**CITY PLAN COMMISSION****THURSDAY, NOVEMBER 3, 2022****FILE NUMBER:** S223-010**SENIOR PLANNER:** Mohammad H. Bordbar**LOCATION:** between Tracy Street and McKinney Avenue, north of Webb Avenue**DATE FILED:** October 6, 2022**ZONING:** PD 193(LC)**PD LINK:** <https://dallascityhall.com/departments/city-attorney/Articles/PDF/Article%20193.pdf>**CITY COUNCIL DISTRICT:** 14    **SIZE OF REQUEST:** 2.176-acres    **MAPSCO:** 35R**OWNER:** McKinney Webb Holdings, LLC

**REQUEST:** An application to replat a 2.176-acre tract of land containing all of Lots 1 through 3, Lots 6 through 14, all of Lot 2A, Lots 1E through 1G in City Block 5/2018, and abandoned portion of Tracy Street to create one lot on property located between Tracy Street and McKinney Avenue, north of Webb Avenue.

**PRELIMINARY PLAT**  
**MCKINNEY/WEBB TOWER**  
**LOT 3A, BLOCK 5/2018**

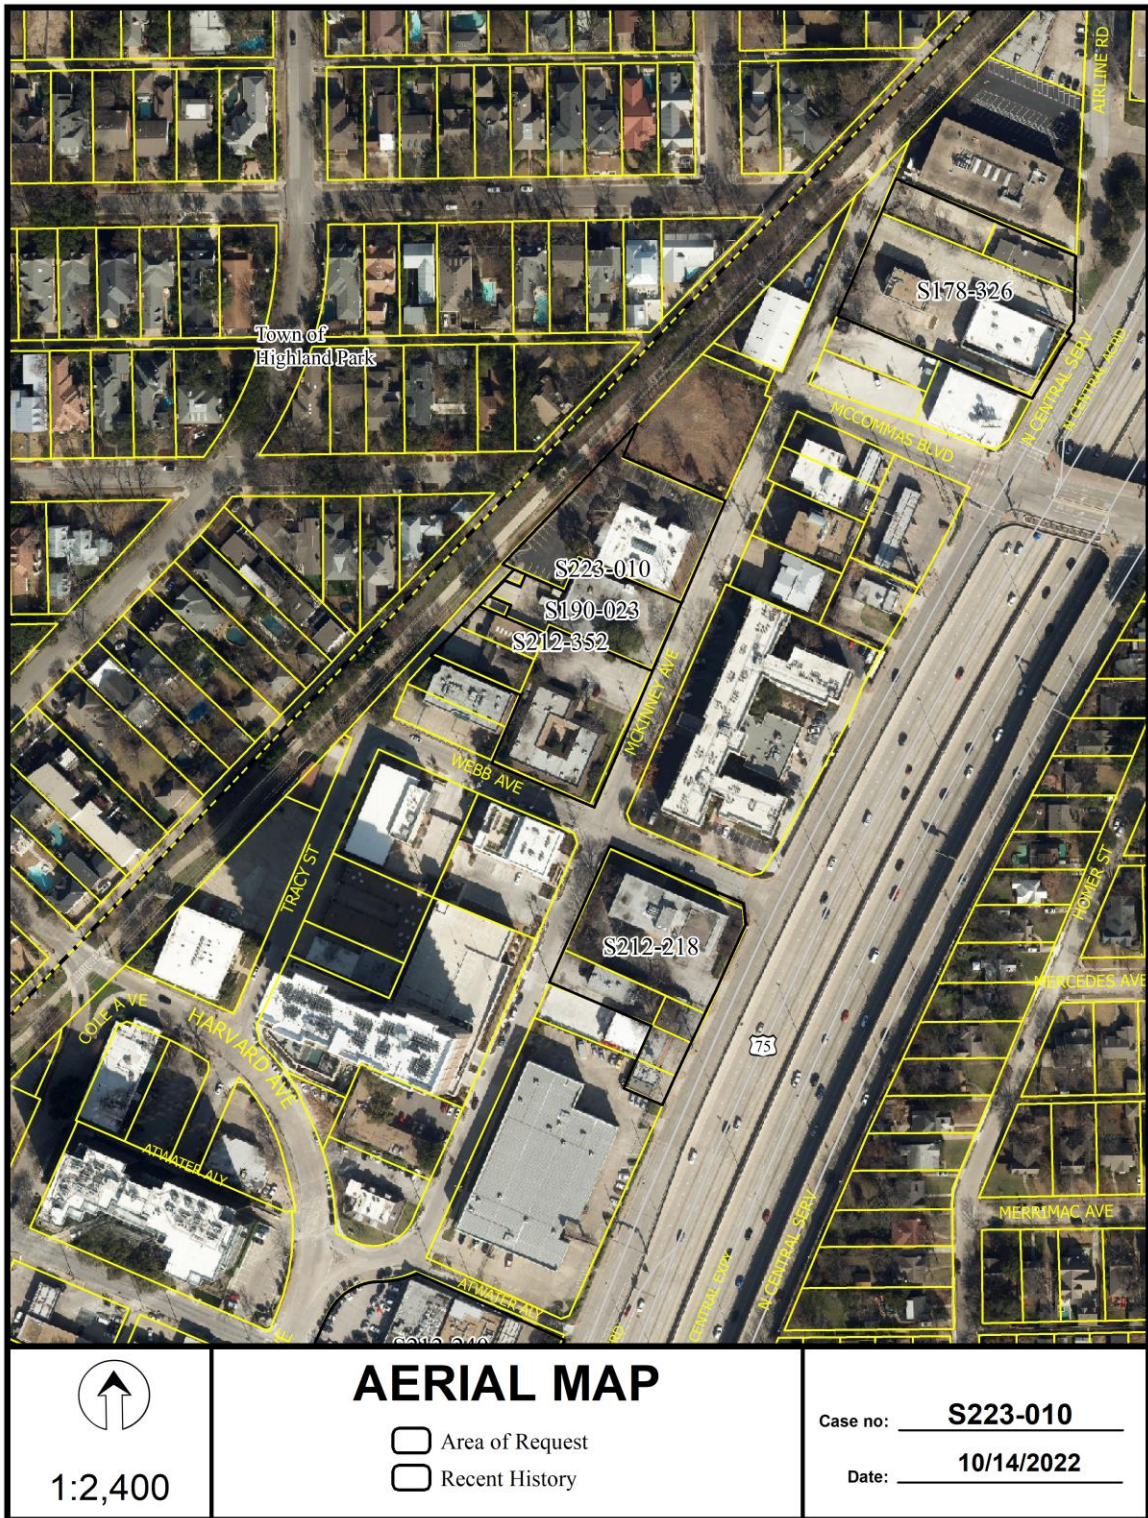
15. On the final plat, dedicate 25 feet of right-of-way (via fee simple or street easement) from the established centerline of Tracy Street. Sections 51A-8.602(c), 51A-8.604(c)
16. On the final plat, dedicate a minimum 10-foot by 10-foot corner clip (via fee simple or Street easement) at the intersection of McKinney Avenue and Webb Avenue. Section 51A 8.602(d)(1).
17. A larger corner clip may be requested during engineering plan and traffic review to accommodate an adequate turning radius, or to maintain public/traffic appurtenances with the area of corner clip. Section 51A 8.602(d)(1), Section 51A-8.608(a)

18. On the final plat, show recording information on all existing easements within 150 feet of property.
19. On the final plat, show distances/width across all adjoining right-of-way. Platting Guidelines
20. On the final plat, show recording information on all existing easements within 150 feet of the property.
21. On the final plat, show all additions or tracts of land within 150 feet of the property with recording information. Platting Guidelines.

22. Additional design information is required for assessment. Site plan must be submitted showing proposed development, building finished floor elevation, development, existing mains – including downstream manhole, and proposed water and wastewater service locations. Submit water/wastewater engineering plans to 320 E. Jefferson Blvd., Room 200, Attention: Water and Wastewater Engineering.
23. Water and wastewater main improvements may be required by Private Development Contract. Submit water/wastewater engineering plans to 320 E. Jefferson Blvd., Room 200, Attention: Water and Wastewater Engineering.

24. On the final plat, show abandonment of portion of Tracy Street as: "Abandonment authorized by Ordinance No.\_\_\_\_\_, recorded as Inst. No.\_\_\_\_\_. Utility Easements retained." Real estate release is required
25. On the final plat, change "Webb Avenue (F.K.A. Webb Street)" to "Webb Avenue (A.K.A. Webb Street)".
26. Contact the City of Highland Park to confirm "Dartmouth Avenue" is accurate.
27. On the final plat, identify the property as Lot 1H in City Block 5/2018. Ordinance 1A, Page 131 pages 131-148, Section 2 (passed August 13, 1872).
